# Intel<sup>®</sup> StrongARM<sup>®</sup> SA-1111 Microprocessor Companion Chip

Specification Update

*October 1999*

Order Number: 278260-007

Figure 2-1. SA-1111 Block Diagram

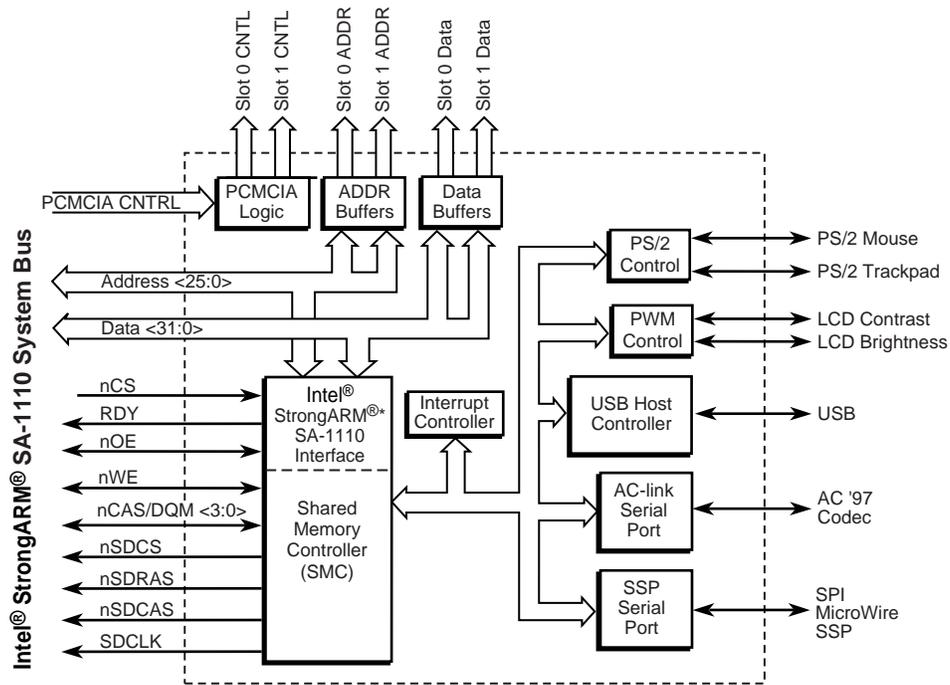
Changed the signal nOE in Figure 2-1 from an input to a bi-directional arrow. Figure 2-1 now appears as follows:

Figure 3-7. SDRAM Read Cycle, Burst of 2 - CAS Latency = 3

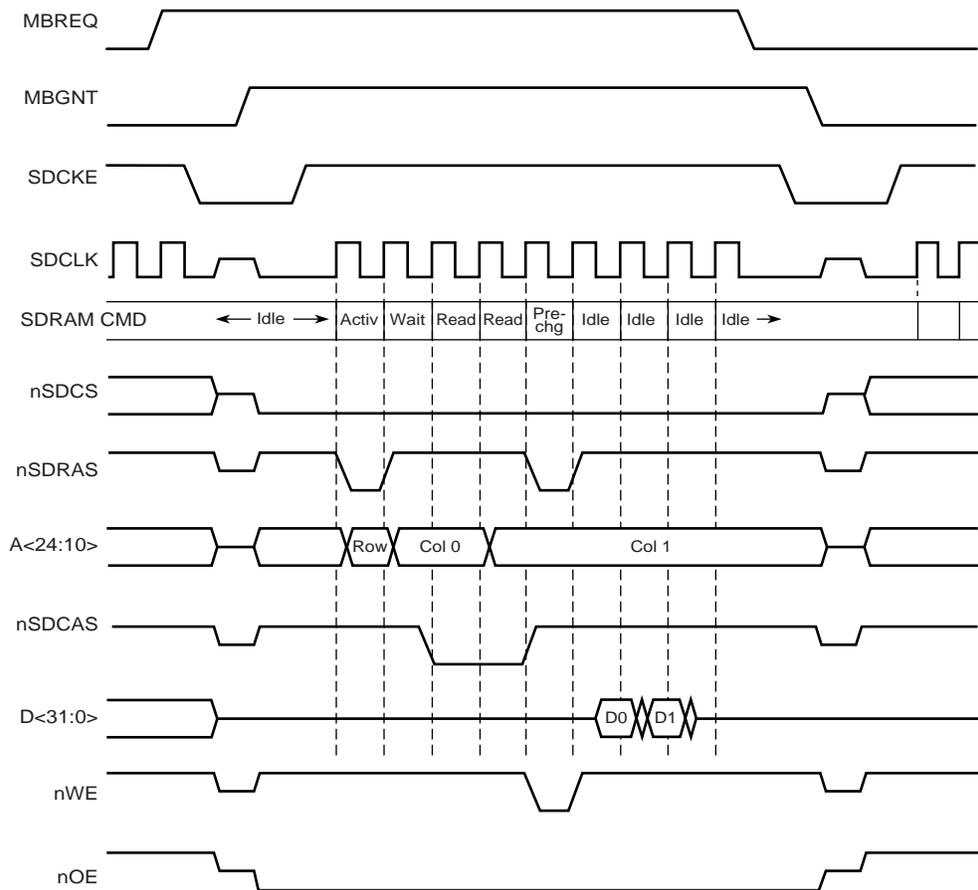
Signal nOE added to bulleted list, added text to this section, updated Figure 3-7 and Figure 3-8. This section now appears as follows:

The SMC also drives signal nOE during DMA transfers. The behavior of nOE is programmable for use in systems with different bus architectures. The nOE behavior may be enabled or disabled. For example, a design may limit system bus loading by placing buffers and transceivers between the SA-1110 (with its system memory) and other peripherals, including the SA-1111. For DMA cycles, the SA-1111 must move data through the transceivers in either direction, depending on whether it is a read or write transfer. Signal nOE may be used to control transceiver direction if it is enabled. When enabled, it is asserted low on reads to SDRAM, and remains high for writes.

Other systems may not require nOE assertion for DMA transfers. If it is disabled, nOE is still driven by the SA-1111 but remains high (deasserted) for both reads and writes.

Figure 4-1. Decoder Block Diagram

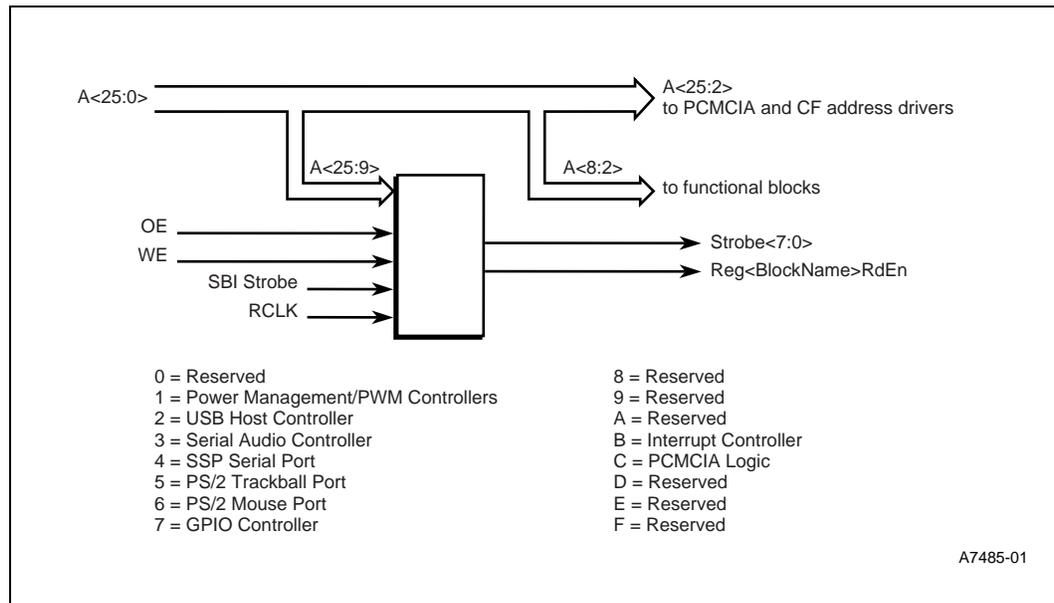
Updated address assignments in Figure 4-1. Figure 4-1 now appears as follows:
